**Piper Aircraft, Inc.**  
2926 Piper Drive  
Vero Beach, Florida, U.S.A. 32960

# SERVICE BULLETIN

NO. 1266

**FUEL WARNING PLACARD AND POH INSPECTION**

**Figure 1**

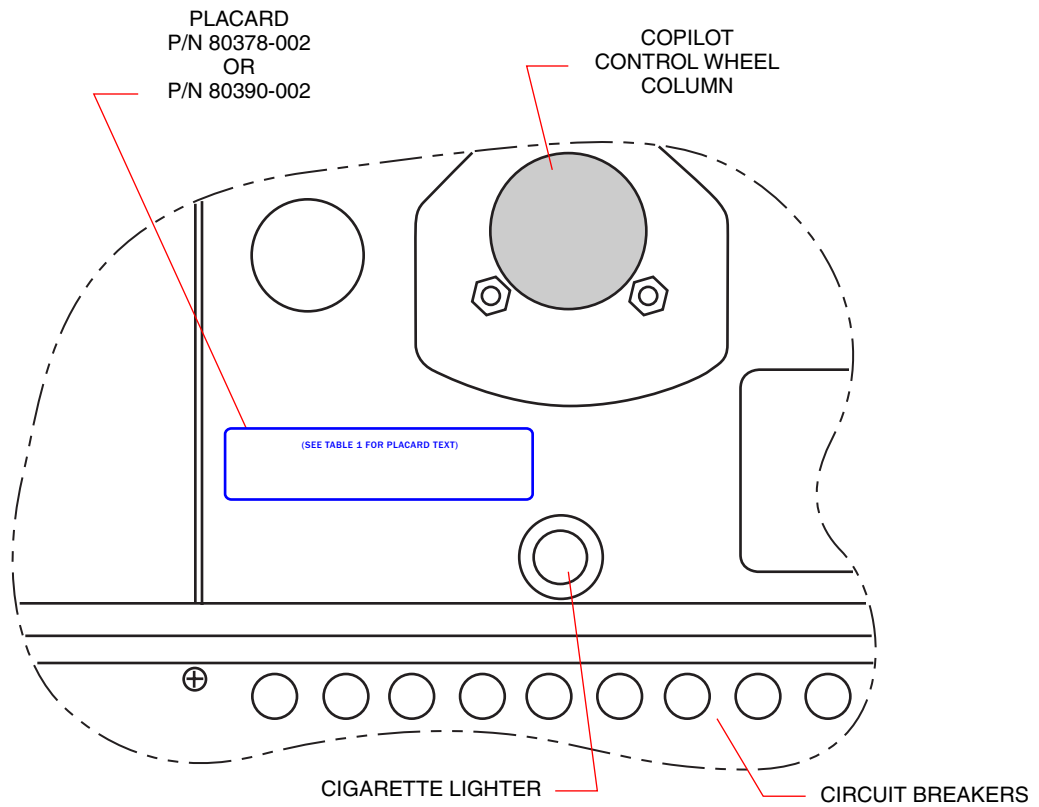
WARNING PLACARD, LOWER RIGHT SIDE OF INSTRUMENT PANEL

1. RC – Using Table 1 and Figures 1 through 4, identify the fuel warning placard, if installed, on the airplane. Compare the text on the installed placard with the corresponding text in Table 2.

- If the text on the installed fuel warning placard exactly matches the corresponding text in Table 2, there is no need to replace the placard. Proceed to Step 2.
- If no fuel warning placard is installed, or if the text on the installed fuel warning placard *does not* exactly match the corresponding text in Table 2, then a replacement placard must be installed. Order and install the applicable fuel warning placard shown in Table 1 and Figures 1 through 4.

Warning Placard - PA-24-250 (FI), PA-24-260 (FI), PA-24-260 "C" and PA-24-400 Comanche

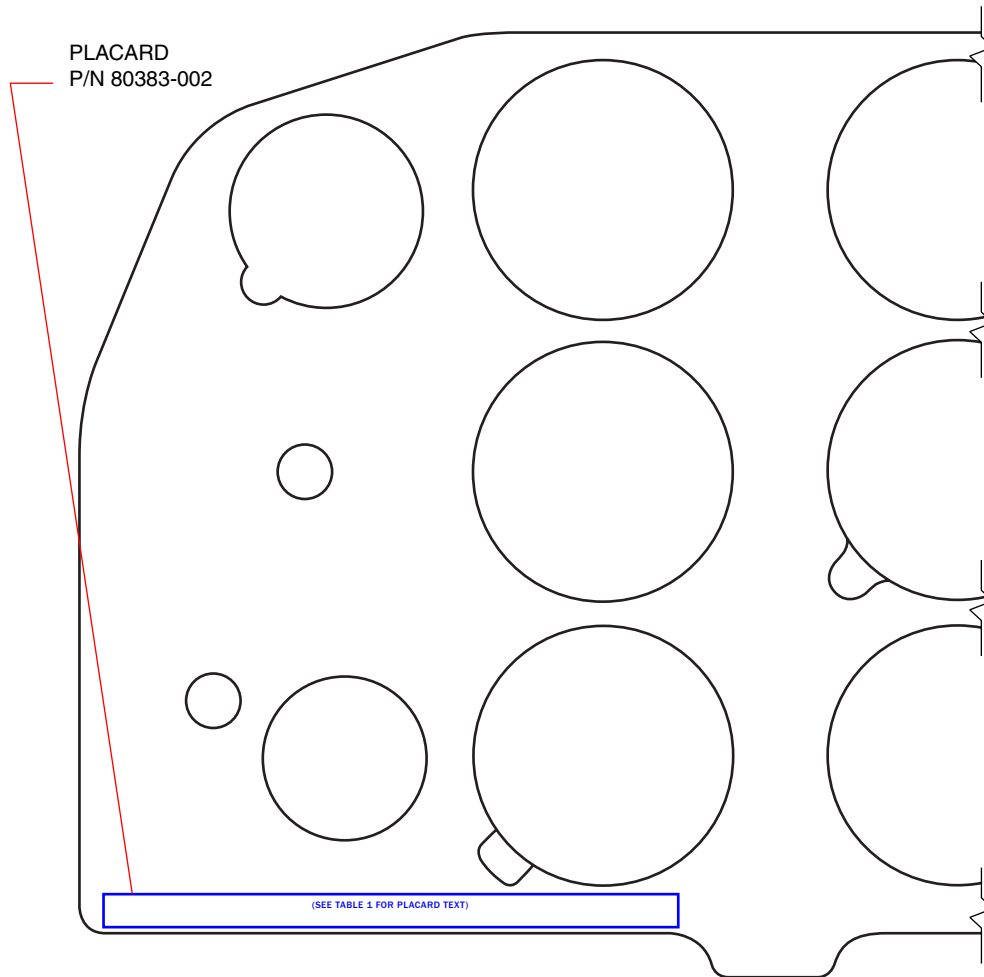
WARNING PLACARD, LOWER LEFT CORNER OF LEFT INSTRUMENT PANEL

**Figure 2**  
Warning Placard - PA-31 and PA-31-300

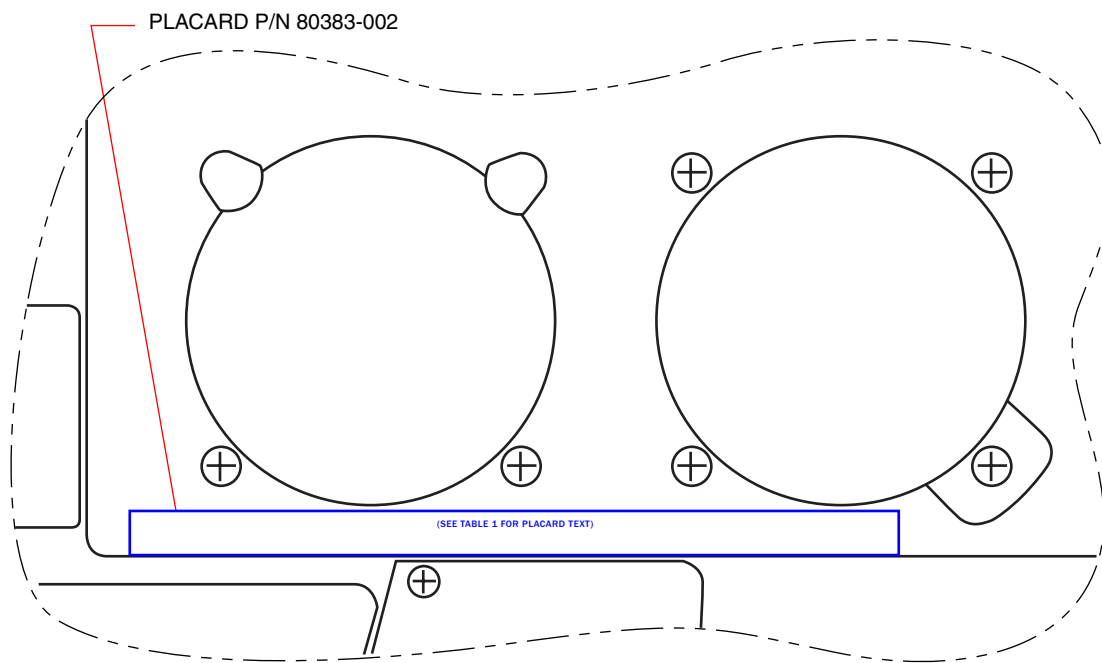
WARNING PLACARD, LOWER LEFT CORNER OF MAIN INSTRUMENT PANEL

**Figure 4**

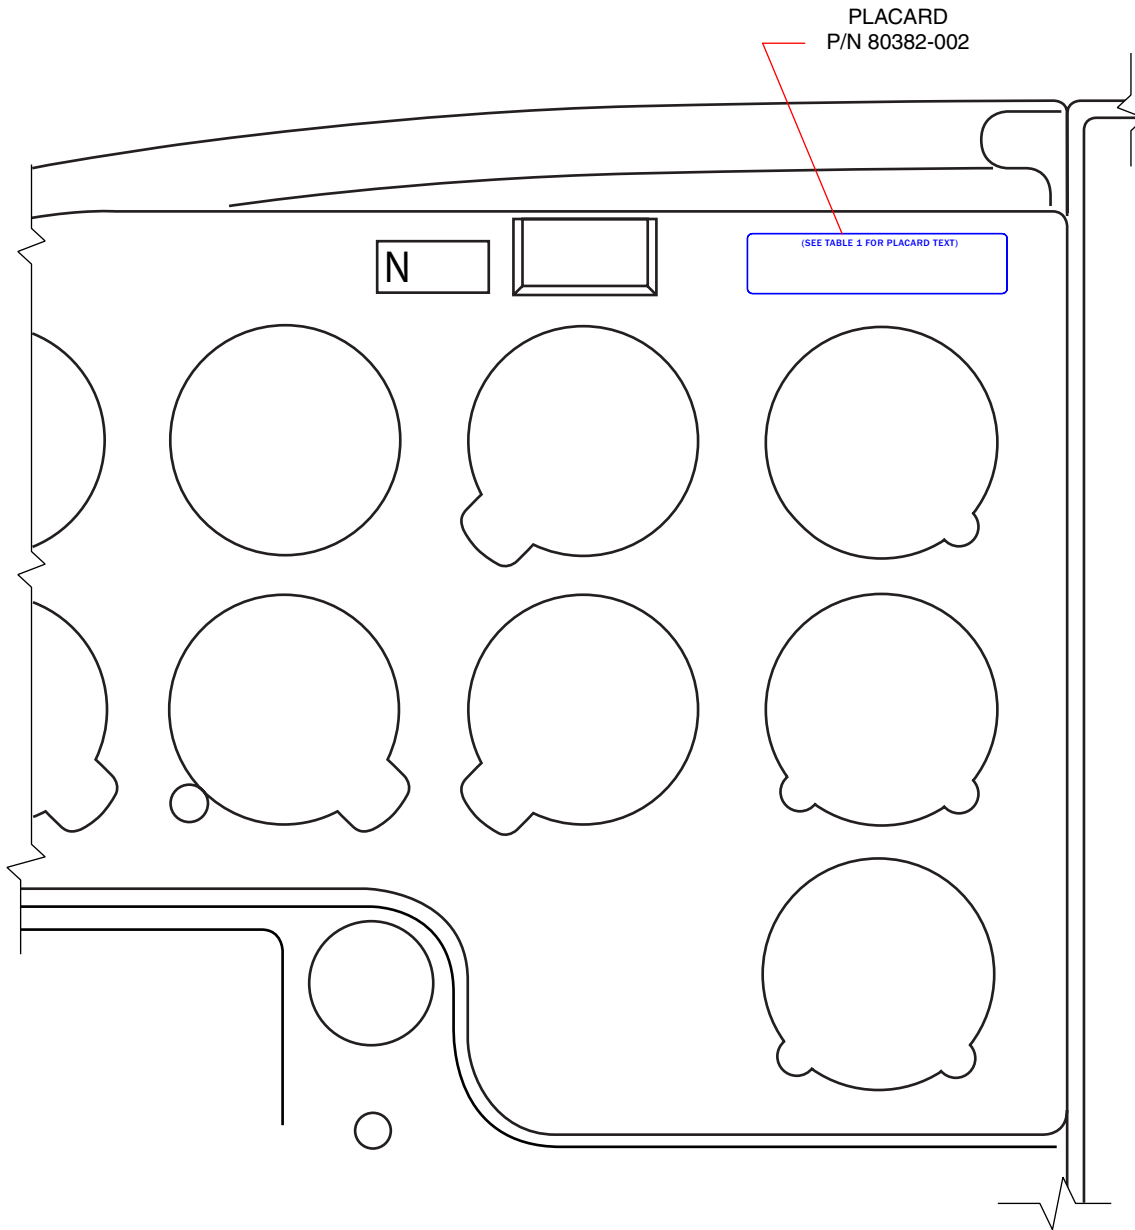
WARNING PLACARD, UPPER LEFT INSTRUMENT PANEL,  
ADJACENT TO THE COMPASS DEVIATION CARD  
AZTEC "E" SHOWN
